Replacement Requirement for Pressure Sensors for Refrigerant Circuit - Mixed Installation Not Permitted (70/24)

Vehicle Type: **Panamera Turbo S E-Hybrid (971)**

Concerns: **Refrigerant circuit pressure sensors**

Pressure sensor part identifier

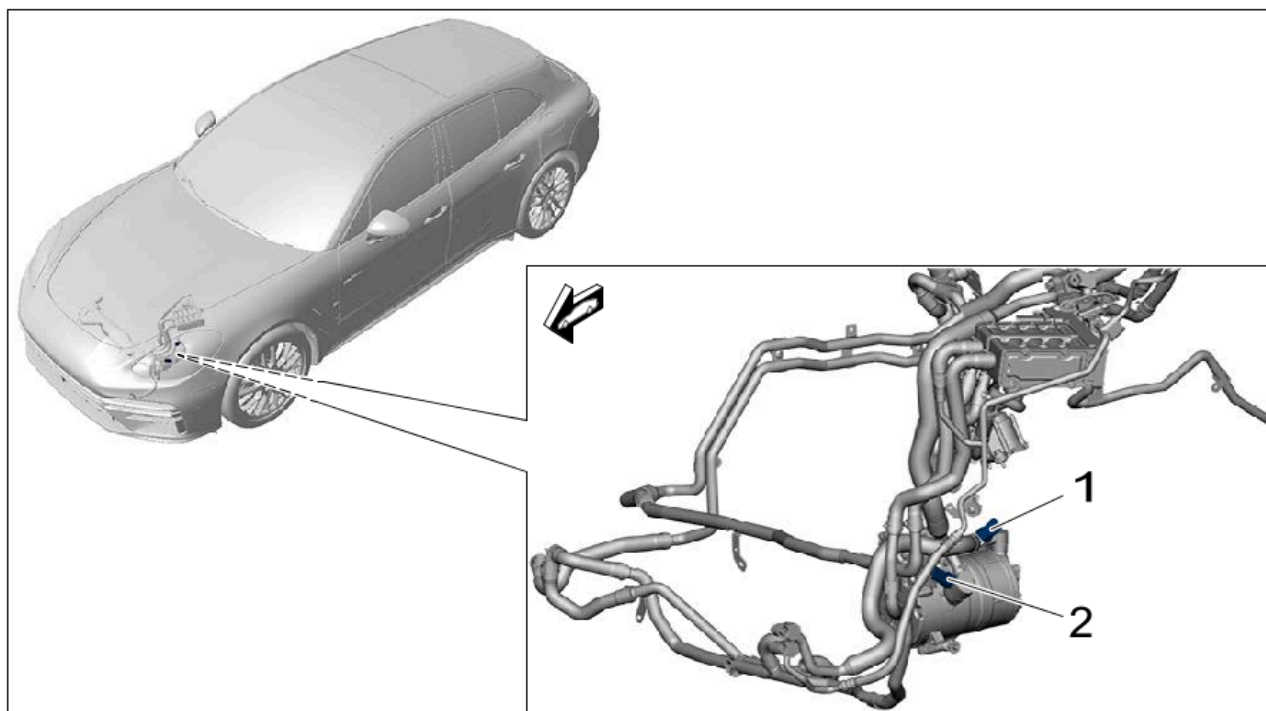
Cause: **Due to the discontinuation of an electronic component within the pressure sensor, the pressure sensors for the refrigerant circuit have been switched to a changed component status.**
 The changed component status can be identified by a changed part number.
 Pressure sensors that correspond to the changed component status are not compatible with the previous pressure sensors.
 If a pressure sensor is required for replacement, it must therefore be ensured that both pressure sensors in the refrigerant circuit correspond to the changed component status (identical part number). If this is not the case, the respective other pressure sensor must also be replaced as a one-off. Mixed installation of pressure sensors with different component status (mixed installation) is not technically permissible and leads to faults in the refrigerant circuit and in the air conditioning.

Part No.	Corresponds to the following part identifier on the component	Designation
PAB959603	4M0959603E	⇒ Pressure sensor for air-conditioning system (previous status, no longer available)
or		
PAB959603B	4M0959603J	⇒ Pressure sensor for air conditioning system (changed status)

Action: If a pressure sensor must be replaced, ensure that both pressure sensors in the refrigerant circuit correspond to the changed component status with the part identifier 4M0959603J.

If this is not the case, **both** pressure sensors must be replaced.
